## HISTORIC AND DESIGN REVIEW COMMISSION

April 06, 2016

**HDRC CASE NO:** 2016-118  
**ADDRESS:** 458 FURR DR  
**LEGAL DESCRIPTION:** NCB 6696 BLK 5 LOT 22 W 25 FT OF 23 E 25 FT OF 21  
**ZONING:** R6 H  
**CITY COUNCIL DIST.:** 7  
**DISTRICT:** Monticello Park Historic District  
**APPLICANT:** Jeannette Trujillo/Floodmaster, Inc  
**OWNER:** David & Lydia Lerma  
**TYPE OF WORK:** Window replacement, front door, restore porch  
**REQUEST:**

1. Replace front door.
2. Enclose front porch ceiling.
3. Replace all 27 wood windows with 16 wood windows and 11 vinyl windows.

Existing door and proposed door

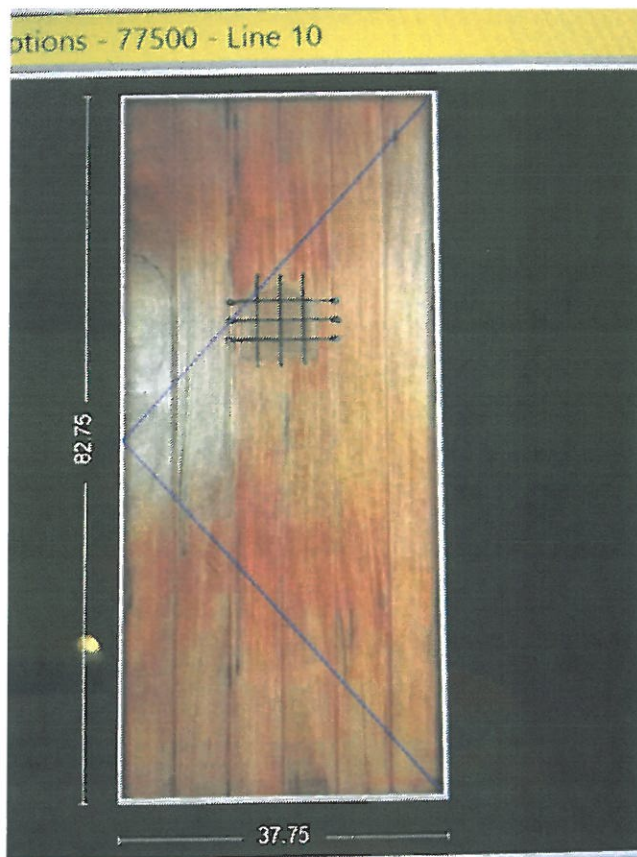
- a. The main structure at 458 Furr Drive is a two-story Spanish eclectic with a clay tile roof, stone façade, front gable and hipped roof.
- b. The existing front door is solid wood with one window lite and decorative bars. The applicant is requesting to replace the existing front door with an in-kind wooden front door. The applicant suggests the current front door has been severely damaged by fire and smoke and requires replacement. According to the Guidelines for Exterior Maintenance and Alterations 6.A.ii., historic doors including hardware and fanlights should be preserved, or replaced in-kind when deteriorated beyond repair. Staff finds replacement of the door appropriate and consistent with the guidelines. Staff finds that there has been substantial damage to the existing door, and finds the replacement to be appropriate.

Staff recommends approval for items #1 and #2. Staff does not recommend approval of item #3. Staff recommends the historic wood windows be repaired, and replaced as necessary with wood windows of the same profile, and should the

Proposed Window sample image

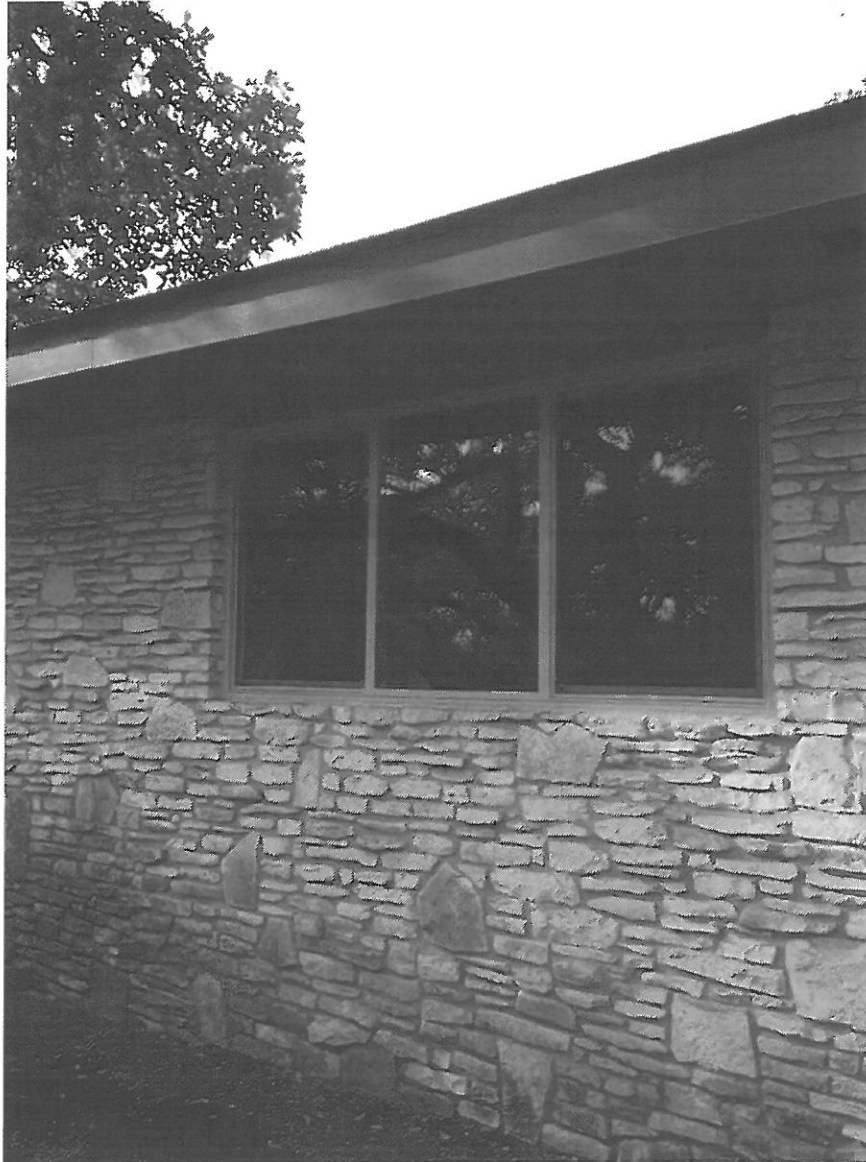
- d. The applicant is requesting to replace all 27 wood windows with 16 wood windows and 11 vinyl windows. The 11 vinyl window replacements are proposed on the rear elevation with the exception of window #5 on the left elevation. According to the Guidelines for Maintenance and Alterations 6.A.iii., historic windows should be preserved unless 50% or more of a window's components must be reconstructed; when windows must be replaced, the Guidelines for Maintenance and Alterations B.iv., states that new windows should be installed to match the historic windows in terms of configuration, material, and appearance. Staff recommends the historic wood windows be repaired, and replaced as necessary with wood windows of the same profile, and should the applicant follow this recommendation, that they return with a window schedule and details of the proposed windows to be installed.

applicant follow this recommendation, that they return with a window schedule and details of the proposed windows to be installed.
